re: **Grading and Site Servicing Plans Review**
Proposed Residential Development
222 Baseline Road – Ottawa, Ontario

date: October 20, 2025

file: PG6324-MEMO.01

Figure 1 - Insufficient Soil Cover (Footings)

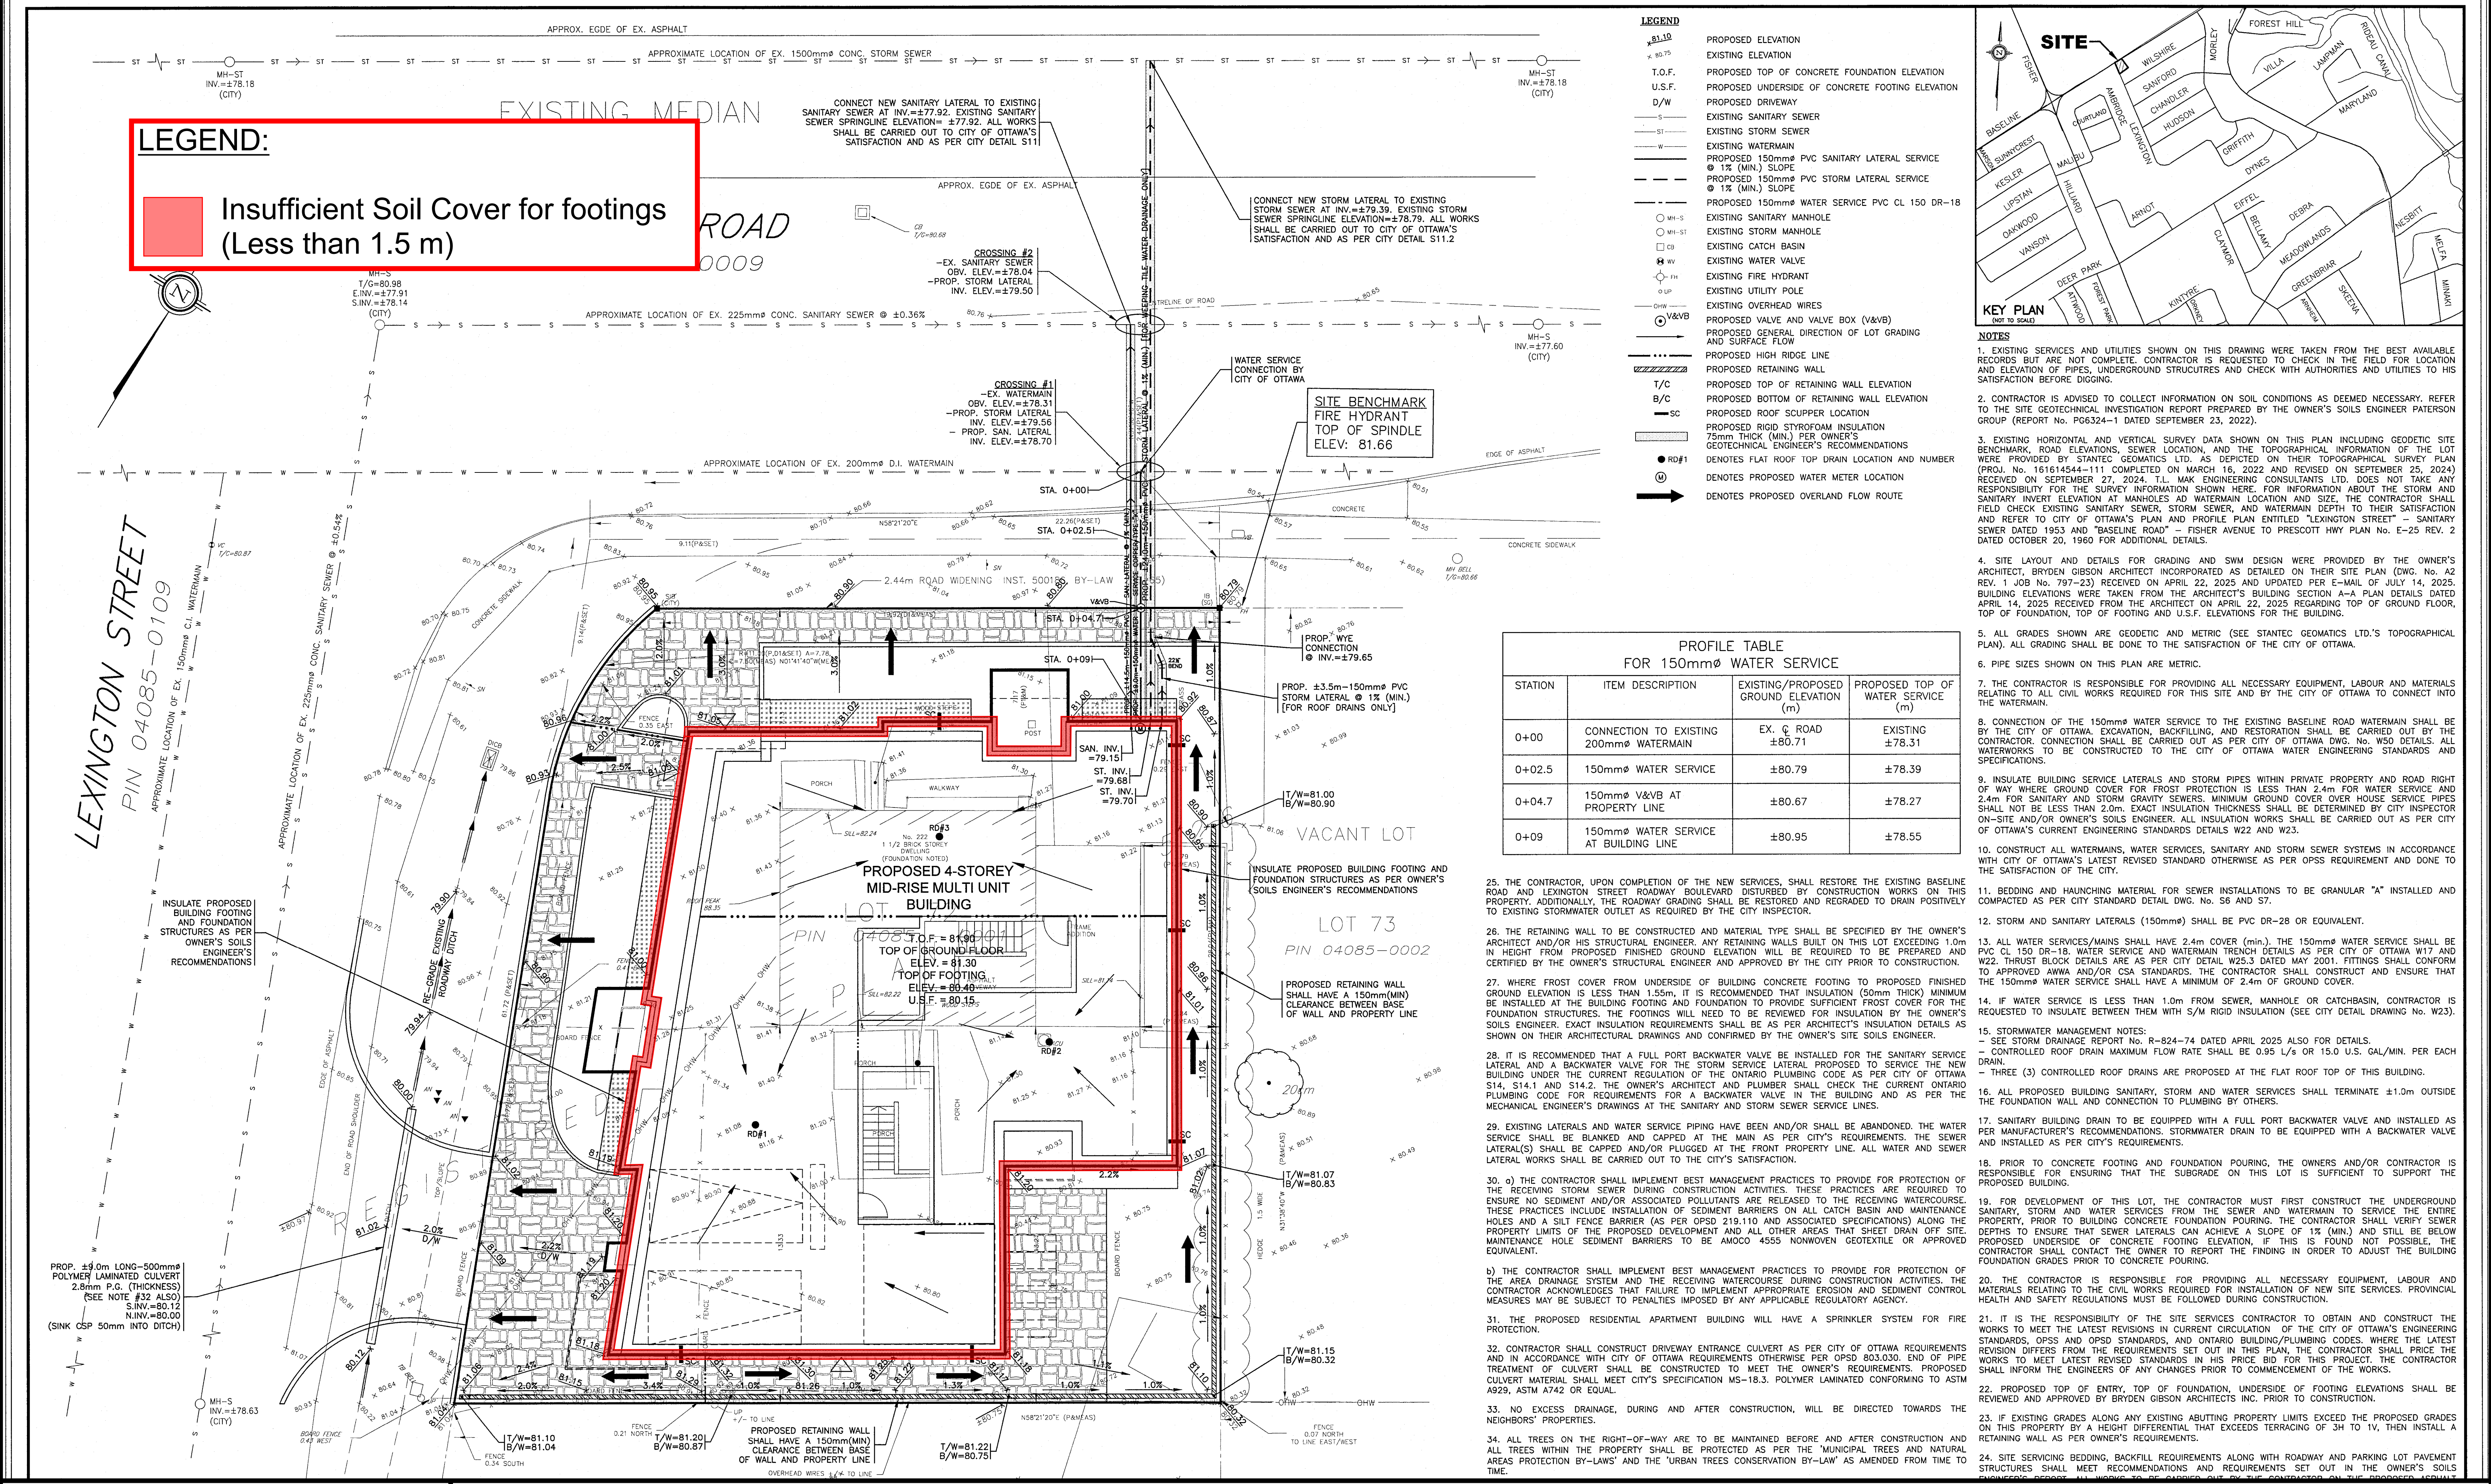
Based on our review of above noted grading plan, the perimeter footings for the proposed development are not provided with sufficient soil cover for frost protection. Therefore, rigid insulation will be required. Reference should be made to Figure 1 – Insufficient Soil Cover (Footings), attached to the current memorandum.

To accommodate insufficient soil cover for the proposed footings, rigid insulation is required to achieve adequate frost protection. Rigid insulation recommendations are presented in Table 1 on the following page.

Thermal Condition	Soil Cover Provided (mm)	Insulation Dimensions	
		Thickness (mm)	Extension (mm)
Heated	1200-1500	25	Extend 900 mm horizontally beyond edge of footing face
	900-1200	50	Extend 1200 mm horizontally beyond edge of footing face
	600-900	75	Extend 1500 mm horizontally beyond edge of footing face
	300-600	100	Extend 1800 mm horizontally beyond edge of footing face
	0-300	125	Extend 2100 mm horizontally beyond edge of footing face
Unheated	1800-2100	25	Extend 600 mm horizontally beyond edge of footing face
	1200-1800	50	Extend 600 mm horizontally beyond edge of footing face
	900-1200	75	Extend 1200 mm horizontally beyond edge of footing face
	600-900	100	Extend 1800 mm horizontally beyond edge of footing face
	300-600	150	Extend 2100 mm horizontally beyond edge of footing face
	0-300	200	Extend 2100 mm horizontally beyond edge of footing face

All rigid insulation placed below the footings should consist of either Dow Chemical High-Load 40 (HL-40), Styro Rail SR.P400, or equivalent approved by Paterson. The rigid insulation placed below the footings should extend a minimum of 100 mm beyond the exterior edge of the footing. Styrofoam (SM) rigid insulation can be used beyond to extend beyond the footing face (above USF). Reference should be made to Figure 3 – Typical Rigid Insulation Detail, attached to this memorandum.

Figure 2 - Insufficient Soil Cover (Services)

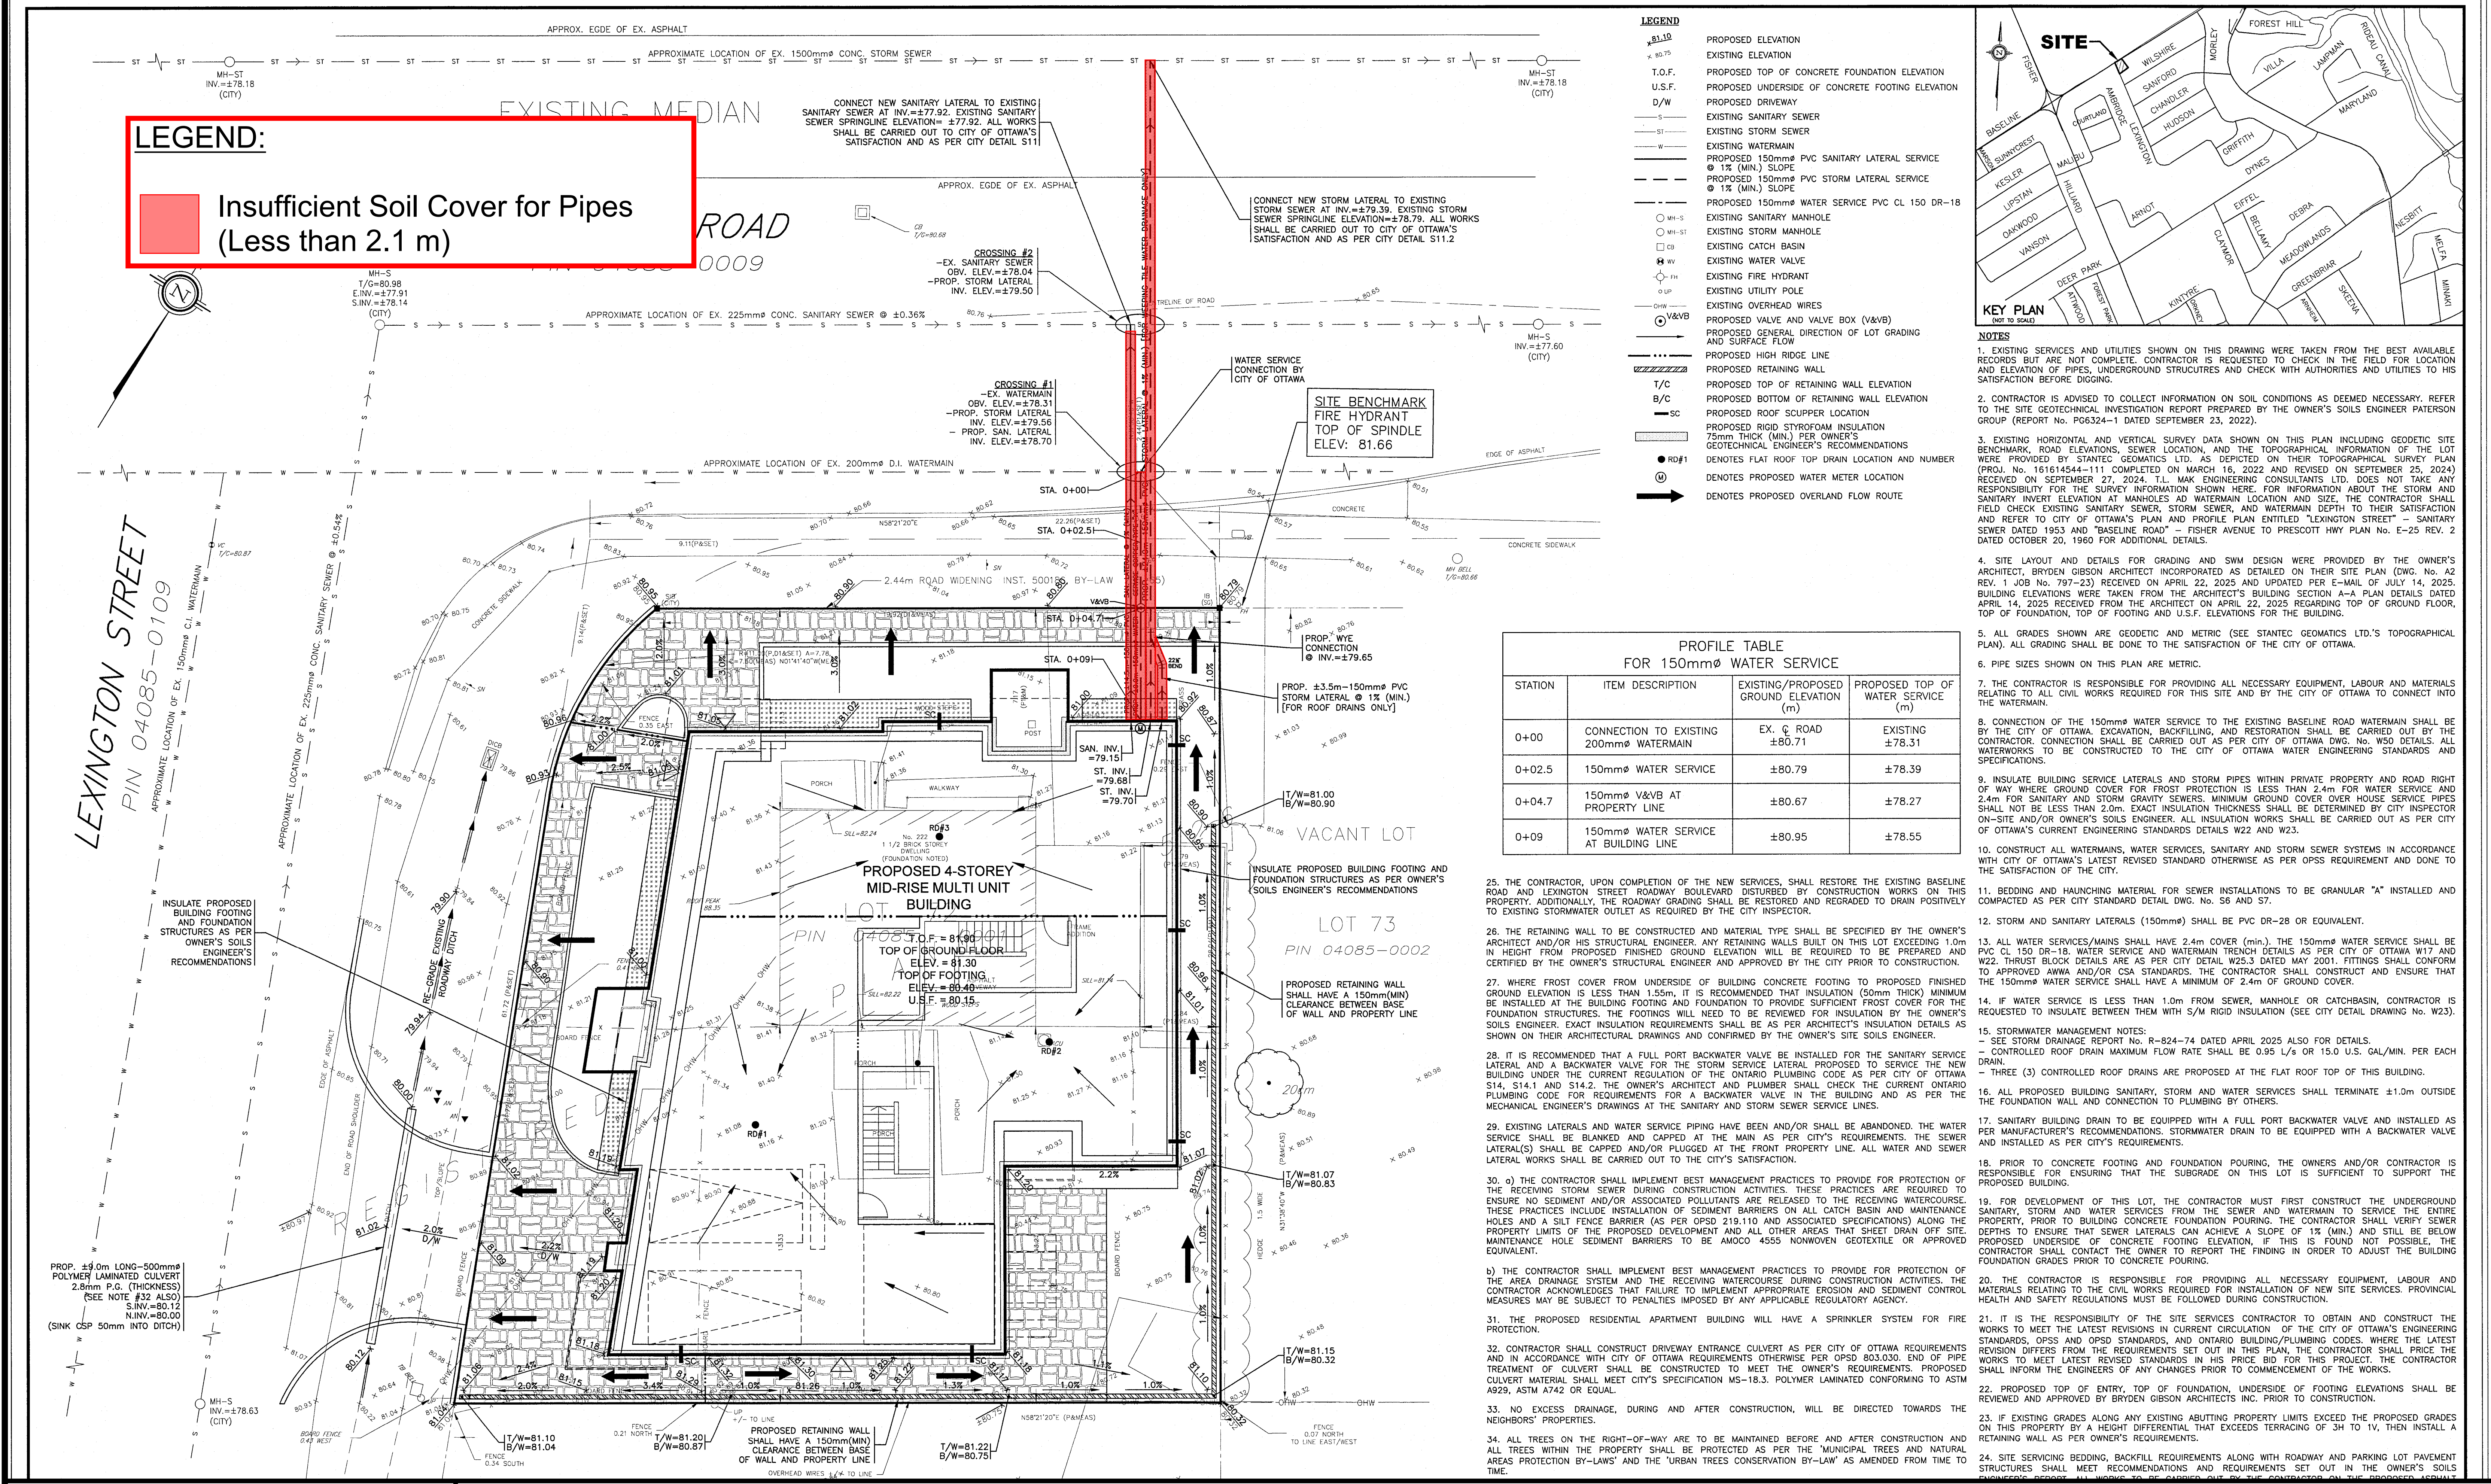
Insufficient frost protection has been provided for some of the proposed sanitary and storm sewer pipes throughout the subject site. Reference should be made to Figure 2 – Insufficient Soil Cover (Services), attached to the memorandum.

The sanitary and storm sewer pipes outlined on the above-noted figure are located within the frost zone of 2.1 m below the finished grade. Rigid insulation to provide adequate frost protection of the site servicing is recommended where insufficient frost cover has been provided. Any portion of the services installed at a depth of 2.1 m below the finished grade or deeper is considered to have sufficient soil cover for frost protection.

To accommodate insufficient soil cover for the proposed footings, rigid insulation is required to achieve adequate frost protection. Rigid insulation recommendations are presented in Table 2 on the following page.

Table 2 – Frost Protection Recommendations for Services with Reduced Soil Cover			
Thermal Condition	Soil Cover Provided (mm)	Insulation Dimensions	
		Thickness (mm)	Extension (mm)
Unheated	600 to 900	125	Extend 1200 mm horizontally beyond edge face of the pipe
	900 to 1200	100	Extend 1200 mm horizontally beyond edge face of the pipe
	1200 to 1500	75	Extend 900 mm horizontally beyond edge face of the pipe
	1500 to 1800	50	Extend 600 mm horizontally beyond edge face of the pipe
	1800 to <2100	25	Extend 300 mm horizontally beyond edge face of the pipe

All rigid insulation should consist of either Dow Chemical High-Load 40 (HL-40), Styro Rail SR.P400, or equivalent approved by Paterson. The placement of all insulation within the service trenches must be reviewed and approved by Paterson personnel at the time of construction. Reference should be made to Figure 3 – Typical Rigid Insulation Detail, attached to this memorandum.
